REMARKS

IN THE DRAWINGS

Applicants respectfully request permission to amend the formal drawing submitted on September 19, 2003 so that the formal drawings conform with the drawings originally filed with the present application. Specifically, Applicants request the following changes to the figures of the formal drawings:

FIG. 3

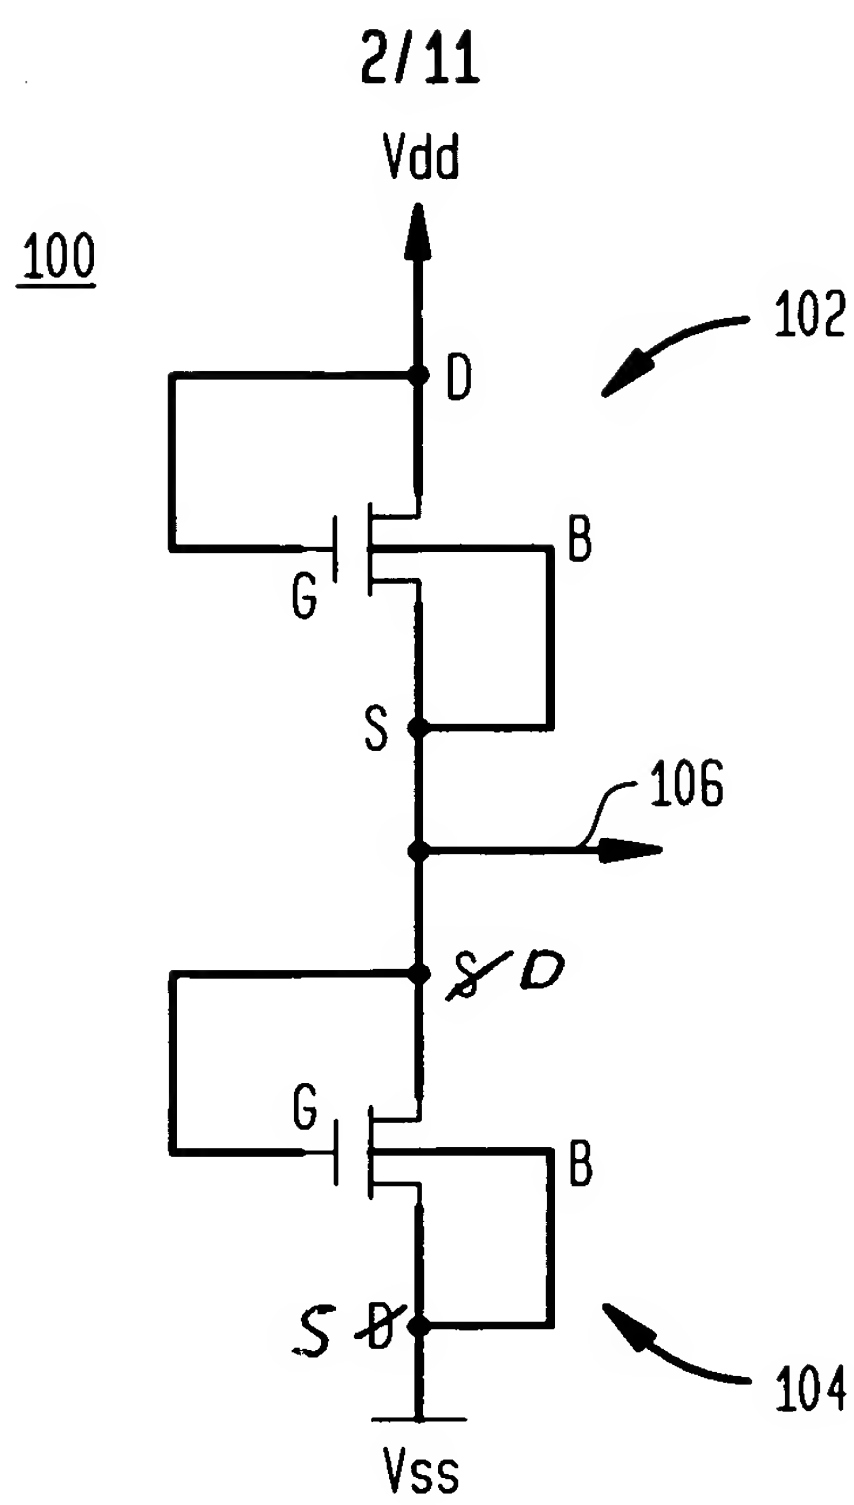
In Fig. 3, at device 104, replace the legend "S" with the legend "D", and replace the legend "D" with the legend "S".

FIG. 7

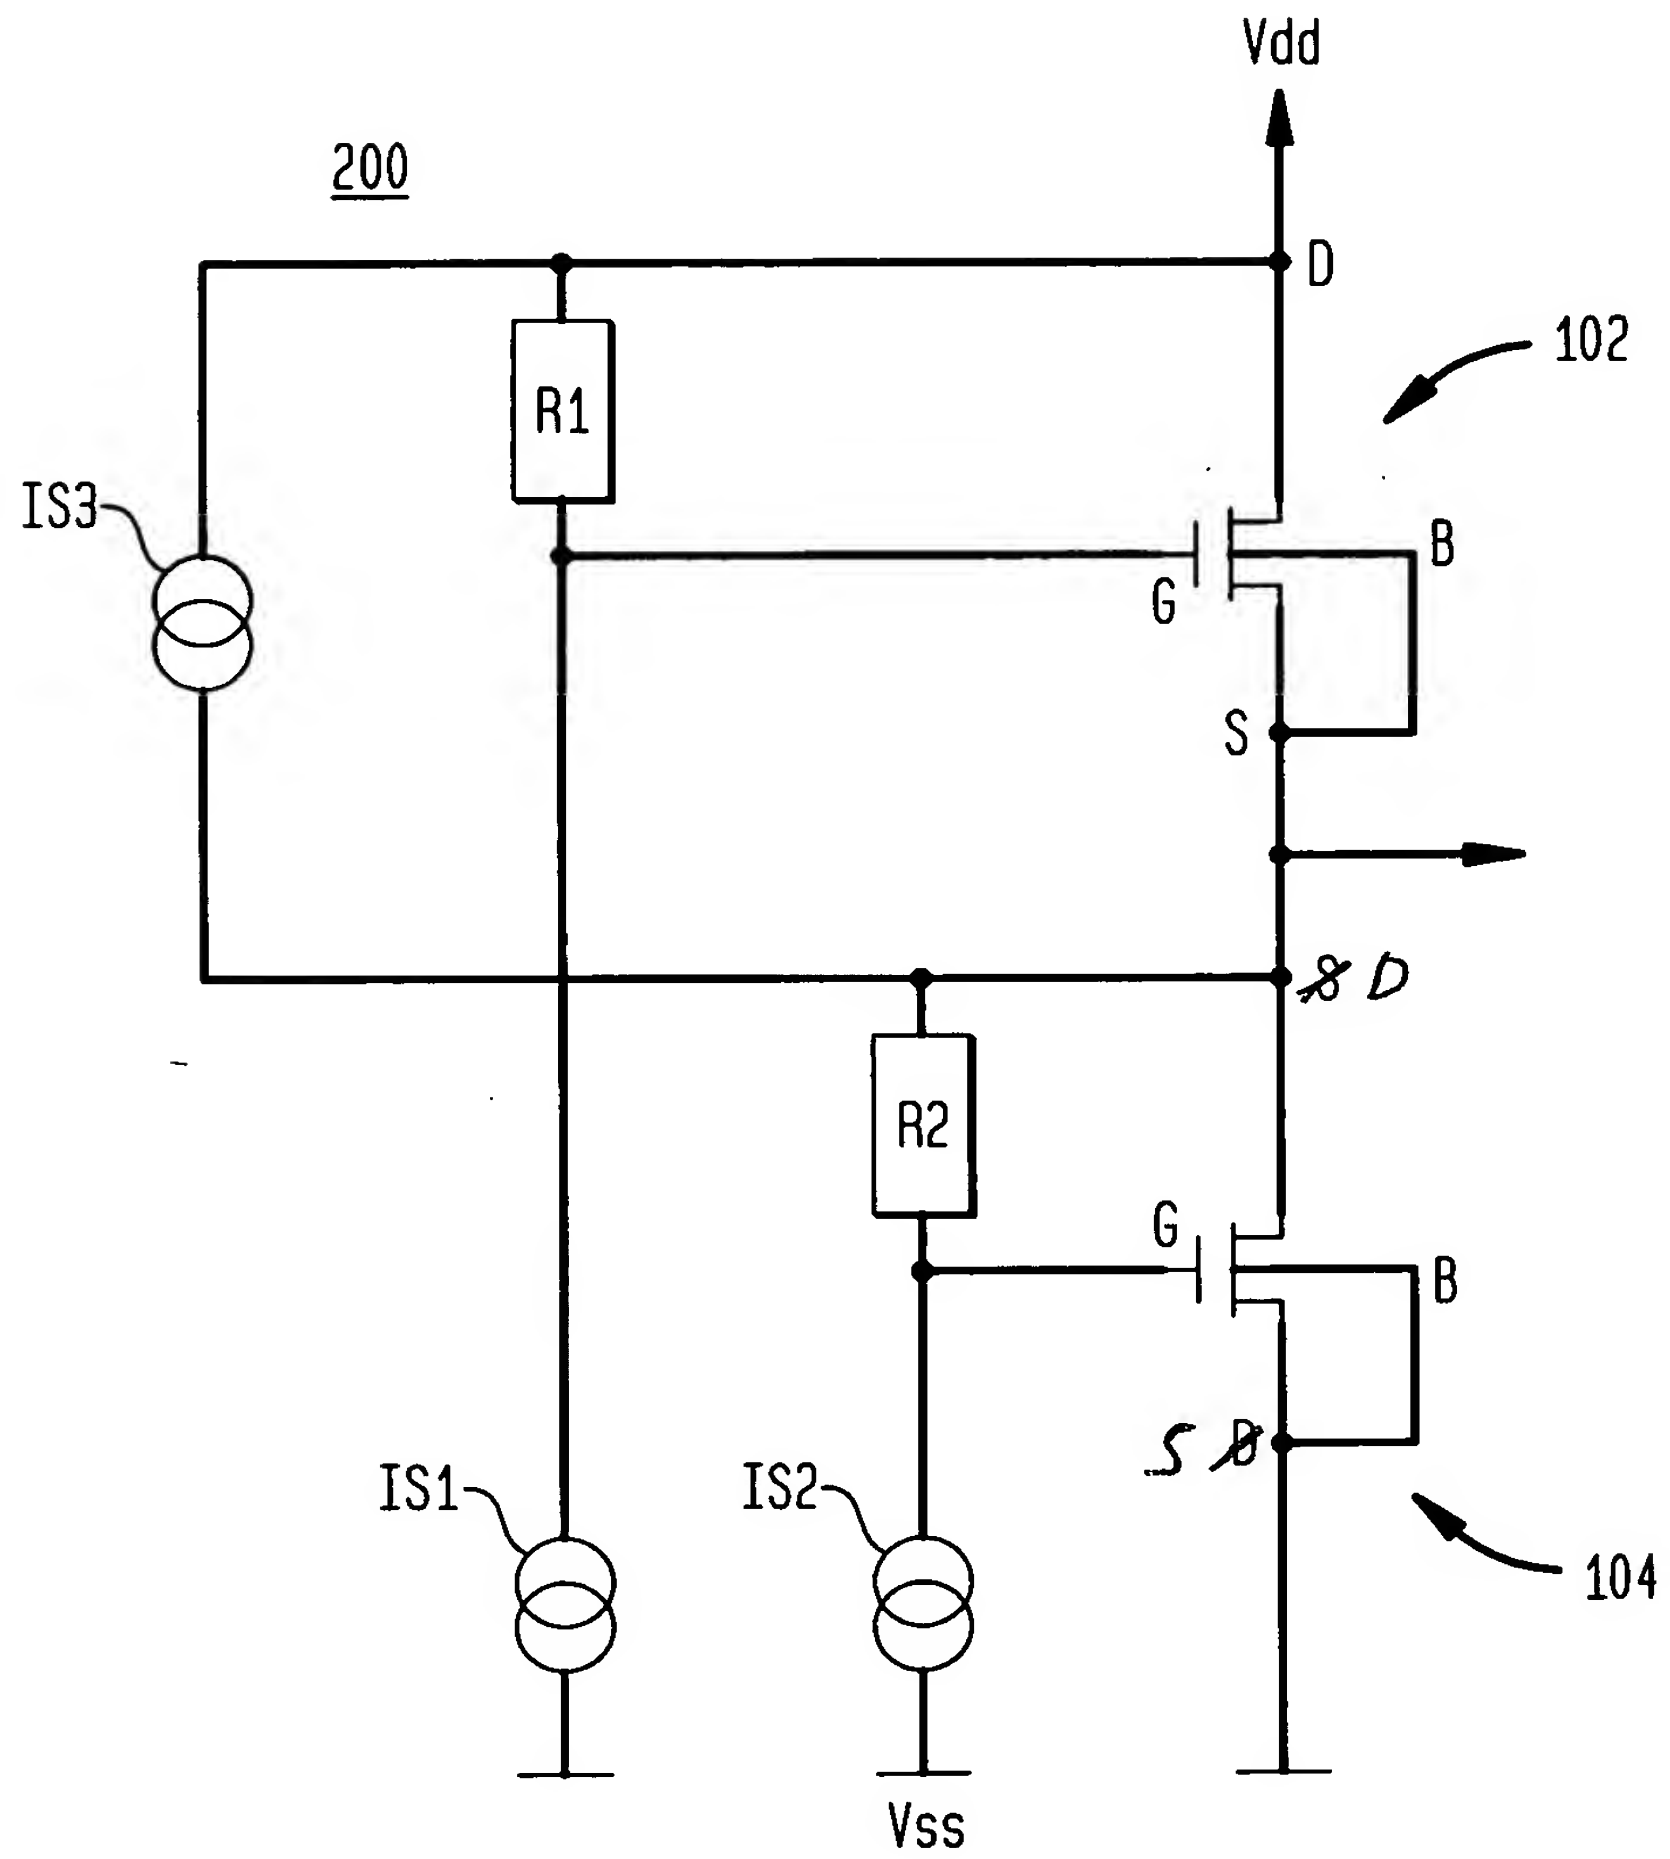
In Fig. 7, at device 104, replace the legend "S" with the legend "D", and replace the legend "D" with the legend "S".
